# PECO NUCLEAR

Subject: Peach Bottom Atomic Power Station, Units 2 and 3  
Response to Request for Additional Information  
Regarding Floor Response Spectra for  
Replacement Recirculation Piping Systems

**Response to Request for Additional Information**  
**Peach Bottom Atomic Power Station, Units 2 and 3**  
**Floor Response Spectra for Replacement Recirculation Piping Systems**

**SUBJECT: Peach Bottom 2 and 3 - GE Response to NRC Questions Pertaining to the Recirculation Piping System Reanalysis**

Figure 2 - E-W Acceleration Time History Power Spectrum

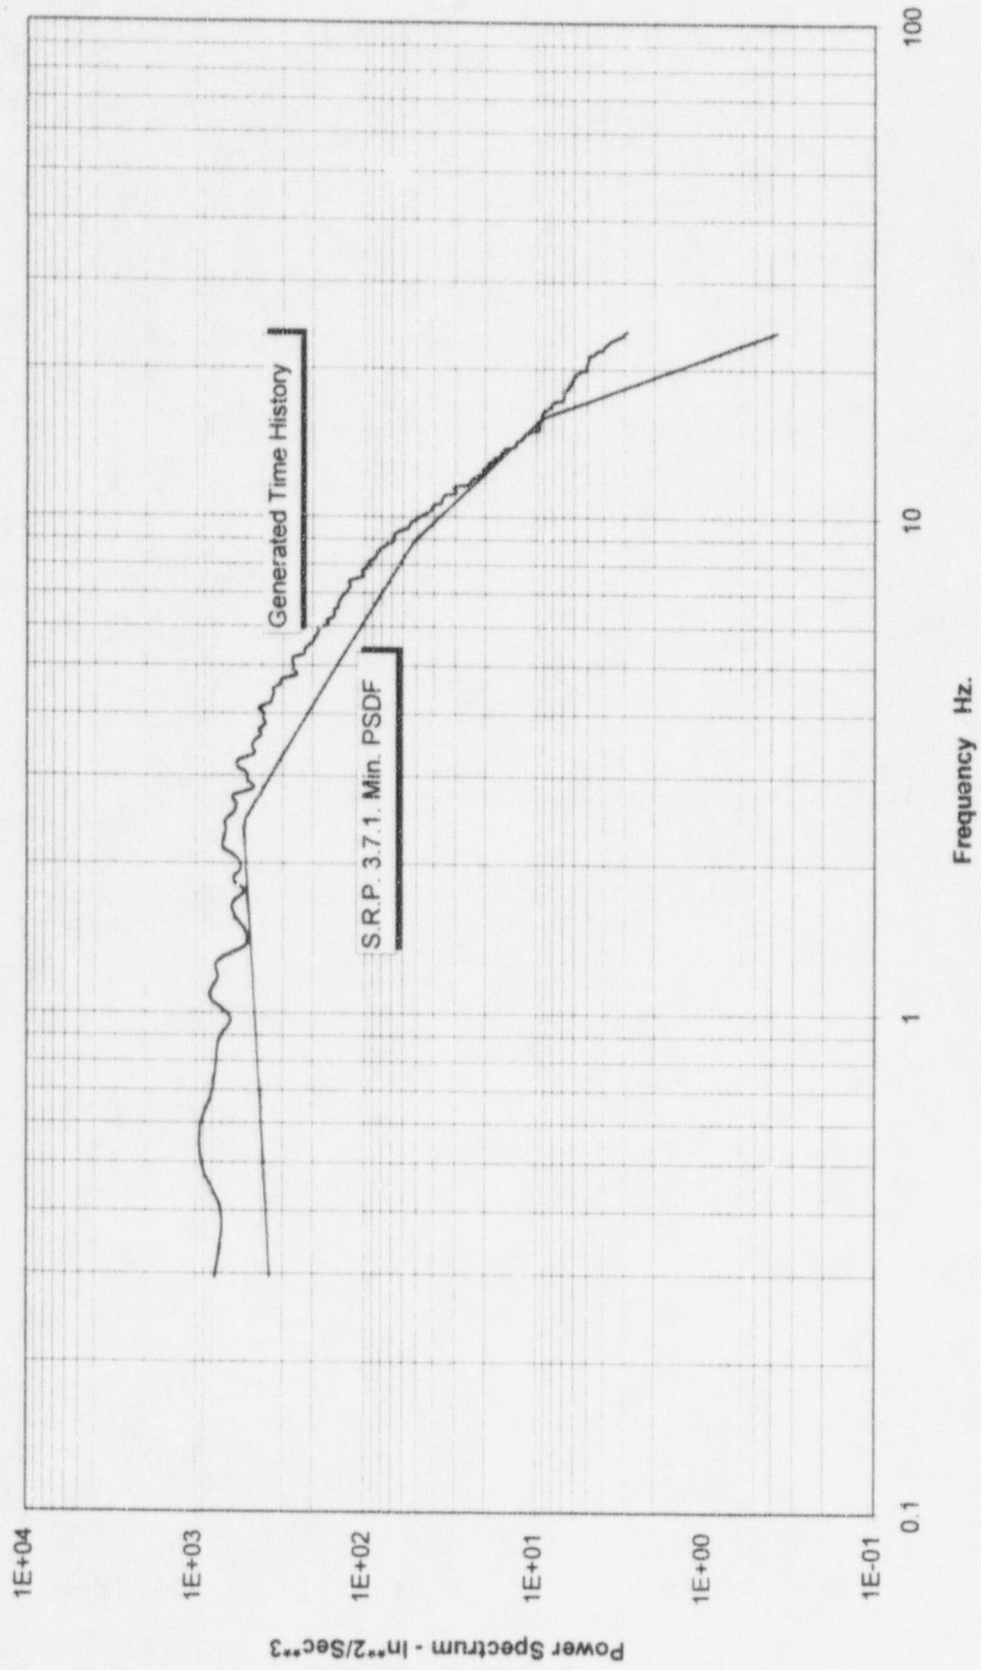
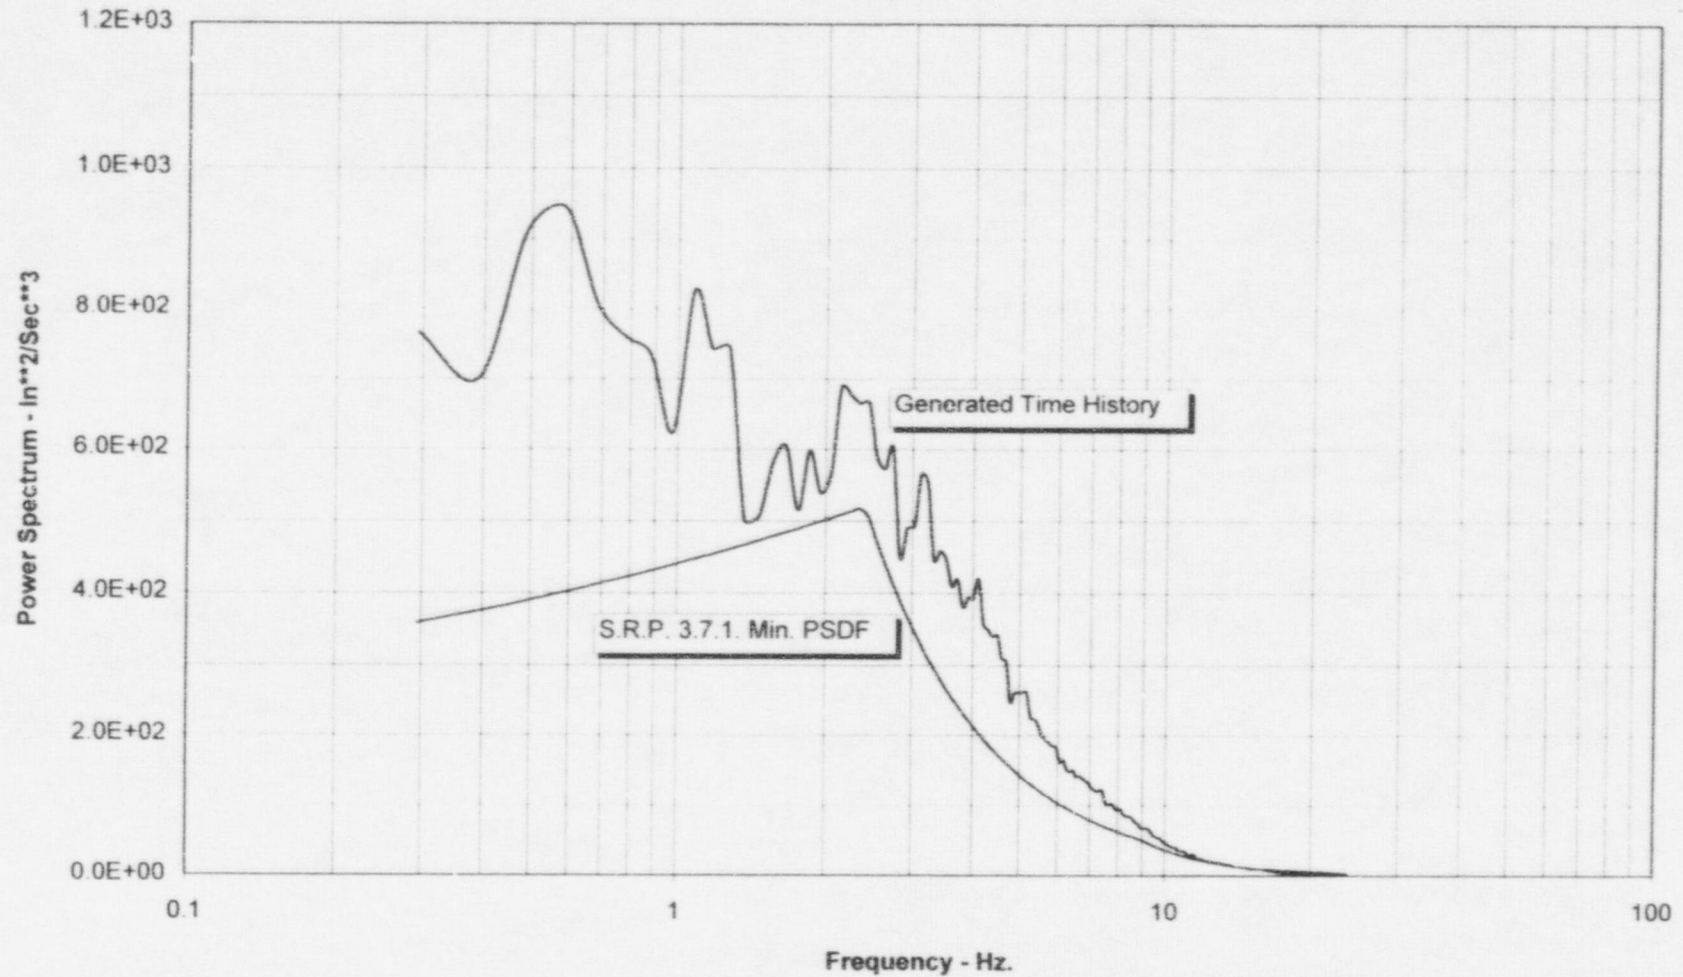
Reference 1 indicates that a single set of artificial time histories (two horizontal and one vertical components) were developed from the RG 1.60 GRS. Demonstrate the adequacy of the artificial time history including the extent of conformance to the target power spectral density (PSD) function of the artificial time history. Provide the actual and target PSDs.

*Item 2. Since PECO used a single time history, it needs to submit a power spectra density (PSD) comparison.*

See the response to item 2 in attachment 2. As can be seen by review of the figures discussed in item 2 of attachment 2, the PSDs from the generated artificial time histories compare favorably to the target PSDs.

**Item 2.** The Power Spectral Density (PSD) comparison plots of the horizontal target PSD from Reference 5.8 (see Equation 2 of Appendix A) and the EW and NS components generated from the SCOTH synthetic time histories are provided in Figures 2 & 3 and Figures 5 & 6, respectively of Attachment A. The PSD from the EW synthetic time history is compared to the horizontal target PSD in the log-log plot in Figure 2. The same comparison, except on a linear-log plot, is provided in Figure 3. Similar comparisons are made for the NS components in Figures 5 and 6.

The generated acceleration time history anchored to peak value of 1g is shown in Figure 1. The accumulated energy for the horizontal acceleration history was computed and is presented in Table 1. From Table 1 it is easily concluded that the strong motion duration of the time history is 10.84 seconds. The PSDF of this strong motion duration segment of the acceleration was computed and is shown in Figure 2. Also shown in Figure 2 is the Minimum Target PSDF. The plots of Figure 2 are presented on a different ordinate scale in Figure 3.

Except in a small frequency window of 13.87 - 15.92 Hz, the Minimum Target PSDF is exceeded everywhere. In the 13.87-15.92 Hz. range the PSDF of the generated acceleration time history is, on the average, about 3.5% below the Minimum Target PSDF. In this region the values of both the Minimum Target PSDF and the PSDF of the E-W acceleration time history are very small and contribute very little to the total power in the earthquake motion. A 3.5% average deficiency of power in this region would, therefore, have an insignificant effect on structural response.

However, if the generated acceleration time history is scaled up by a factor of 1.06, the generated acceleration PSDF would exceed the Minimum Target PSDF at all the frequencies. This small increase in the accelerations would lead to no more than 6% increase in the structural stresses and can be accommodated by the safety margin available in the structural components.

Figure E1 Peach Bottom 2 and 3 - Primary Structure Seismic Model

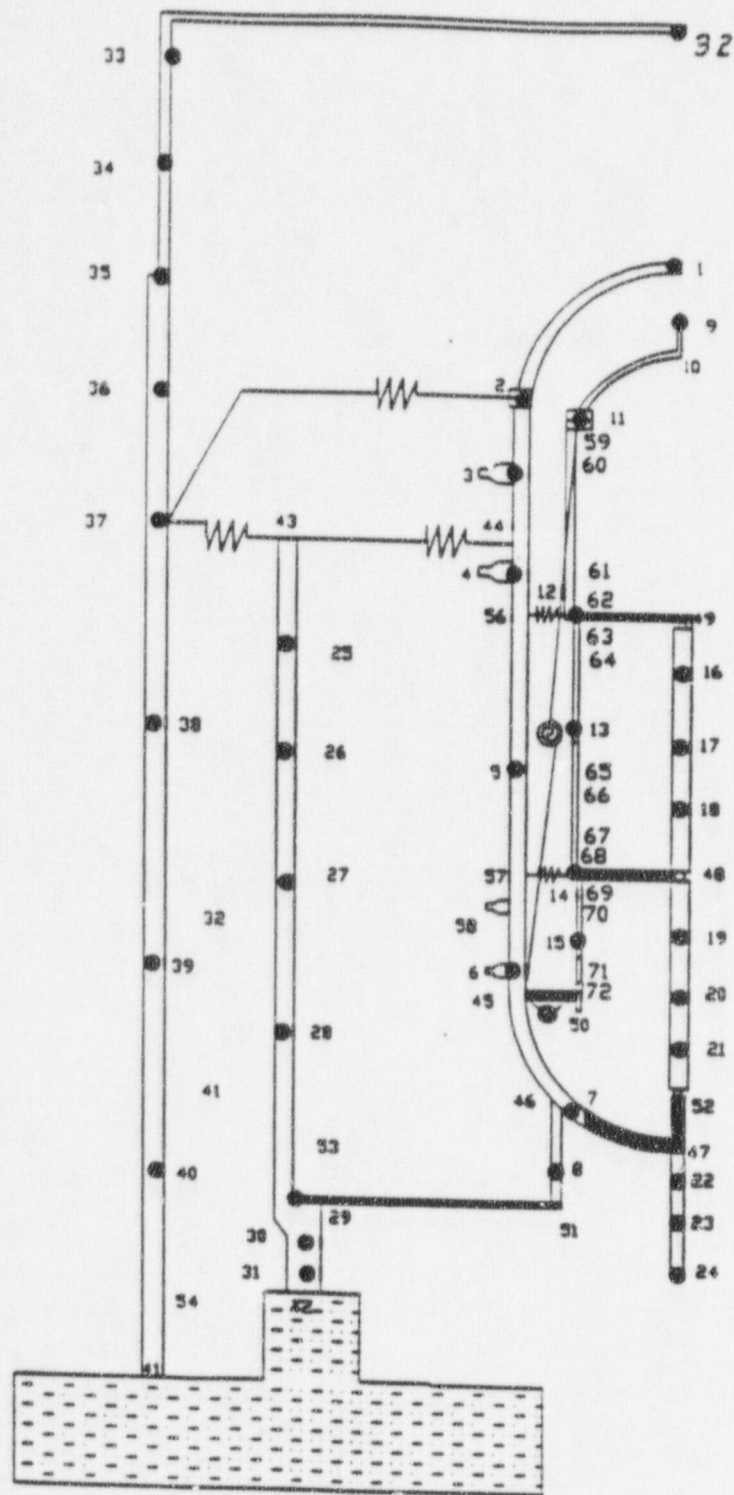
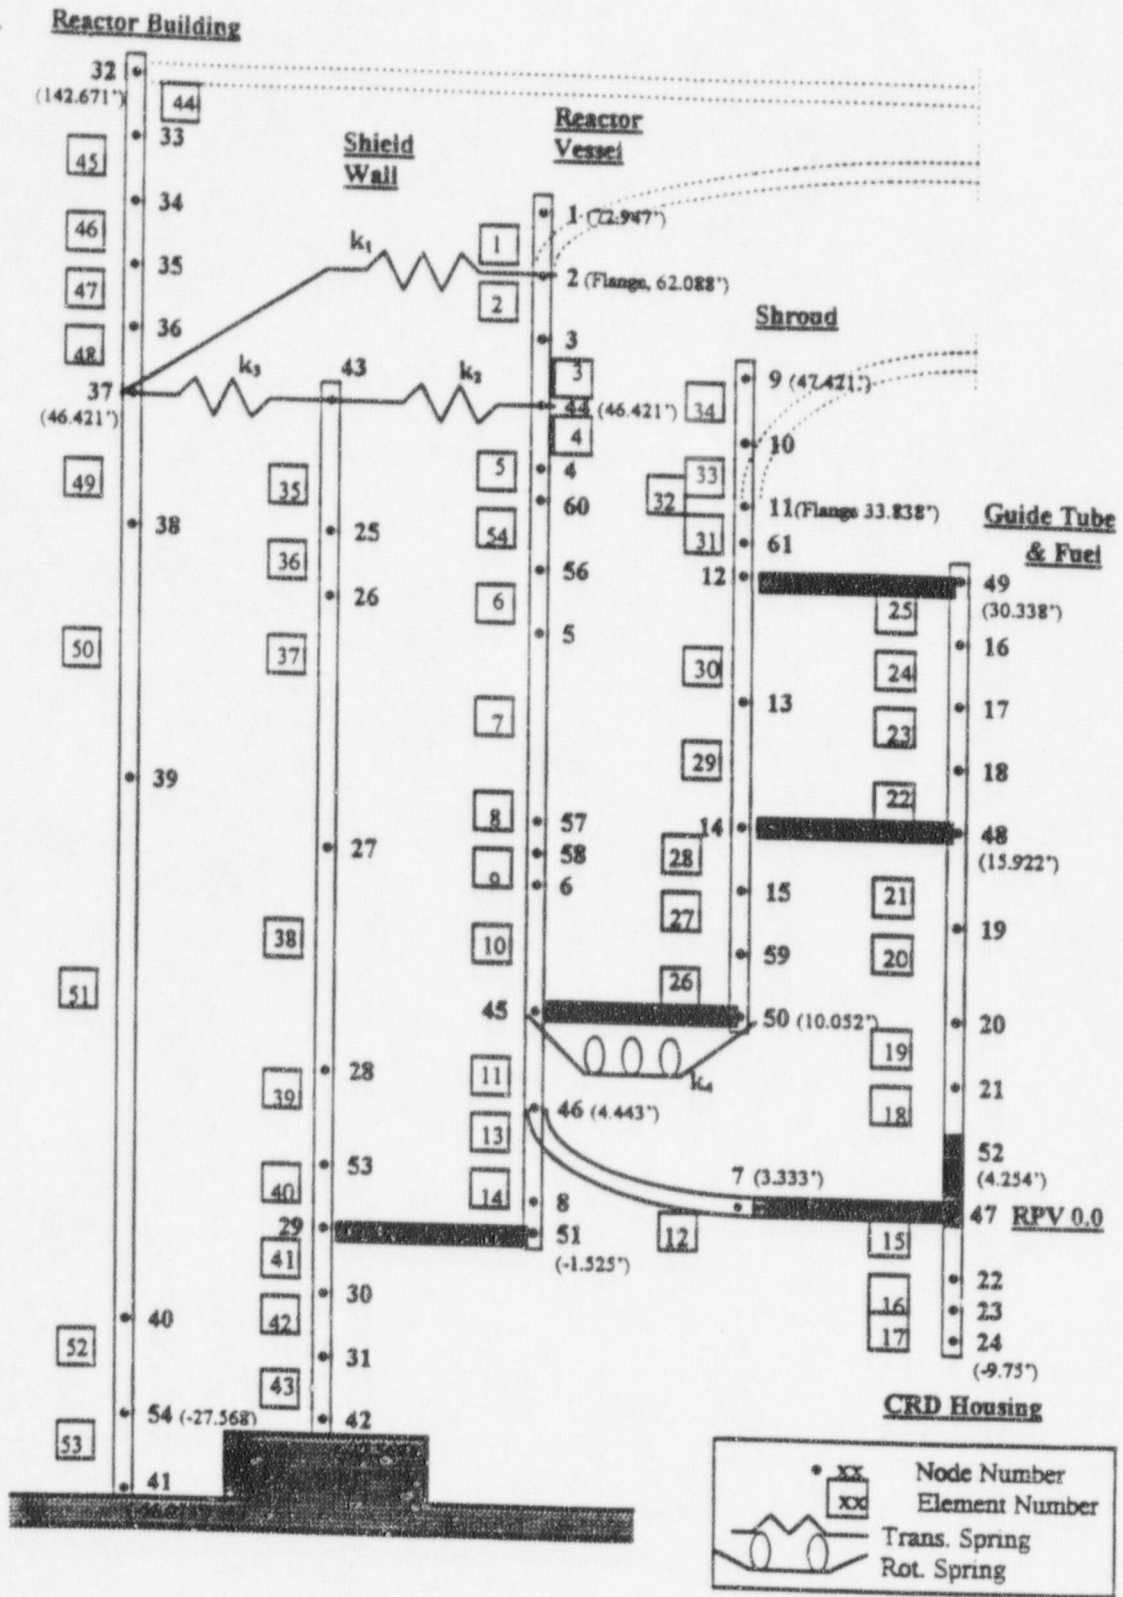
The structural model (Figure E1 of Reference 1) used for the piping analysis is different to the structural model (Figure 1 of Reference 2) used for PECO's shroud repair analysis. In the structural model (Reference 1), some of the horizontal masses are lumped on the vertical stick model, thereby reducing the vertical and eccentricity effects. The structural model for the shroud repair analysis (Reference 2) appears to be more realistic.

Explain the reasons for using the different structural model in the piping analysis, and demonstrate that the model of Reference 1 is as appropriate as the model of Reference 2.

*Item 5. The structural model used for developing the floor response spectra is different to the structural model used for the PECO shroud repair. Explain the reasons for using the different structural model. Since the structural model for the shroud repair looks more realistic, PECO needs to demonstrate the adequacy of the structural model used for piping analysis. Submit floor response spectra based on an analysis in which the time histories used for the piping analysis are applied to the structural model used for the shroud repair.*

**Item 5.** The Peach Bottom 2 & 3 primary structure seismic model use to generate the seismic input motion for the recirculation piping reanalysis is identical to the primary structure "benchmark" seismic model used for the Peach Bottom 2 & 3 shroud repair project, Reference 5.9. The benchmark model does not include the shroud repair hardware or any weld-cracks in the shroud circumferential welds.

For convenience, sketches of the Peach Bottom 2 & 3 primary structure seismic model from both projects are provided in Attachment B. Figure 1 in Attachment B, corresponding to the shroud repair project, was taken from Reference 5.9 and Figure E1 from the recirculation piping reanalysis was taken from Reference 5.6. The depiction of the primary structure seismic model in the two figures is not exactly the same; especially for Node 32 at the top of the reactor building. However, the very same eigenanalysis input geometry was used for both projects. A hard copy of that geometry is provided in Attachment E of Reference 5.6.
